# INITIAL FIRE SAFETY INSPECTION REPORT

**Southeast Sweaters Ltd. NEW – (Extension)**

**RSC ID: 25839**

**Date: 15-Sep-2024**

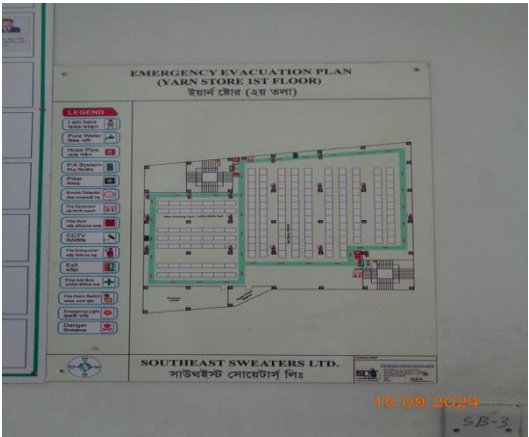
F-2	Means of Egress	<p>The exit stairs are not separated from work areas and other spaces by fire rated construction due to opening, damaged and non functional hardware of fire rated door.</p> <p><b>Location:</b>  <b>B# 1_ Ground Floor (Stair-1), 2nd floor (Stair-2)</b></p>	<p>The exit stair enclosure shall be provided with a minimum 1-hr fire resistance rating for buildings with 3 or fewer stories. Seal all unprotected openings to separate the exit stairs from work areas and other building spaces on all floor levels.</p> <p>Ensure that the fire doors are self-closing and positive latching and that they are provided with fire exit (panic) hardware where serving production floors. If fire doors are required to be held open for functional reasons, provide automatic closing devices tied to the fire alarm system.</p> <p>Factory shall ensure that the maintenance work shall be done for the door hardware and accessories on a regular basis as per NFPA 80 and manufacturer's published guideline. Repair/ replace the hardware and accessories which are not functional or under unauthorized maintenance. Moreover the credibility of the fire rated door shall be ensured through actual datasheet, certificate and listing labeling.</p>	Within 3 Months
